We would like to thank for the valuable comments of the reviewer #1. We have reviewed referee' suggestions, and the necessary changes and explanations will be made in the revised article. An item-by-item summary of our responses to the review comments is provided in this sheet.

*Comment1: This paper discusses the options for reconfiguring a controversial dam project in Turkey.*

Figure 1b

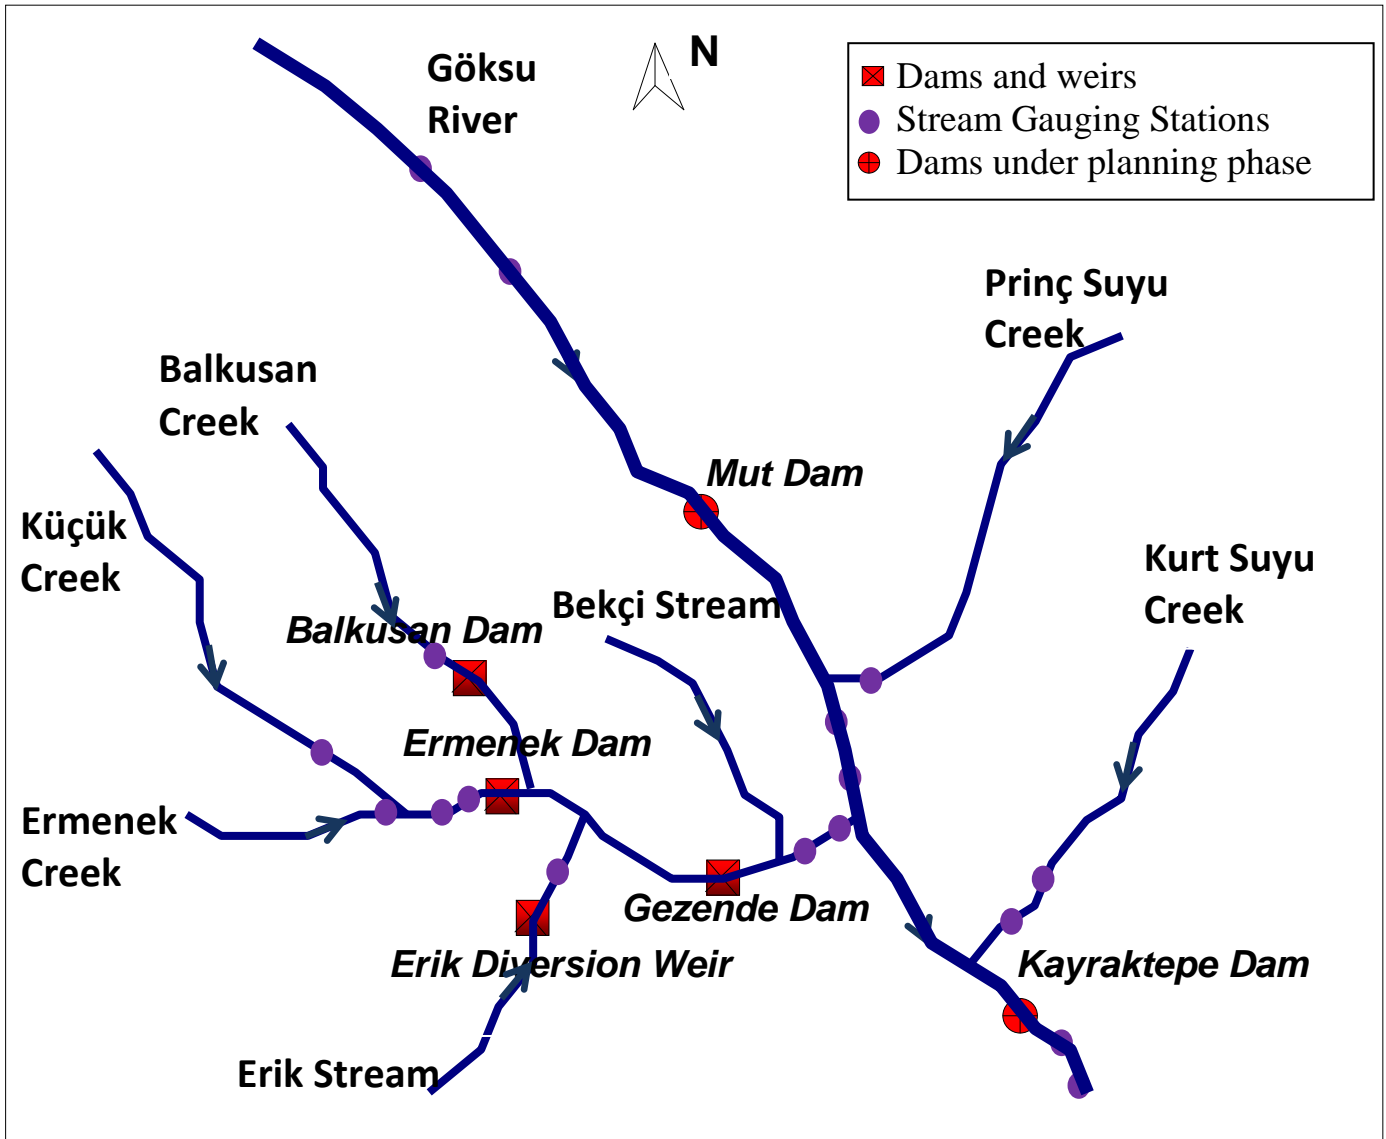
*Page 11773 (line 13) figure 1 is not very clear. It would be useful to indicate which dams have been built and which are planned.*

The Figure 1 is placed very small, we will ask editor if they can enlarge it. In addition we re-draw the Figure 1 which is attached.

Figure 3 Comparison of Kayraktepe 1997 and Kayraktepe 2010 with respect to inundated area.

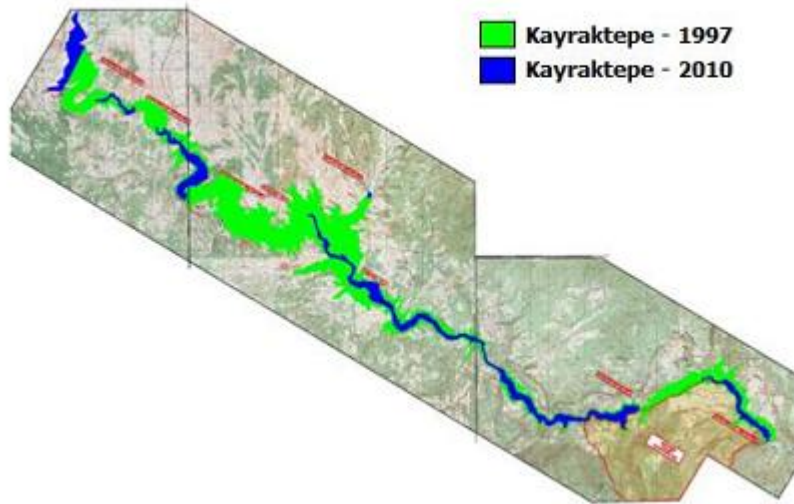
*Page 11779 (line 10-16) This is the first mention of “numerous villages” that would be flooded but there is nowhere in the paper is there discussion of how many households/ people are affected by the different schemes (both upstream and downstream)?*

The English could be tightened somewhat. The figures are not very clear and could be improved by including more detail. A figure showing the difference in area inundated by the different schemes would be useful

The new project (Kayraktepe-2010) consists of one dam and five river run off hydropower plants. The main dam has a height of 53 m and the total lake area will be 820 ha. Number of inundated villigias located in upstream of the dam was 43 and it will force about 2200 people to resettle elsewhere according in Kayraktepe-1982 schema. It is reported that there will be 11 village with 5000 ha land will be flooded if Kayraktepe 1997 will be realized. However, In Kayraktepe 2010 schema, a dramatic reduction in expropriation area by % 83.5 was achived, where originally 5000 ha area was reduced to approximately 820 ha. None of the villages at the upstream will be inundated. A plan

view of Kayraktepe-1997 and Kayraktepe-2010 alternatives were prepared by using a 1/25000 scaled topographic map and can be seen in Figure 3.
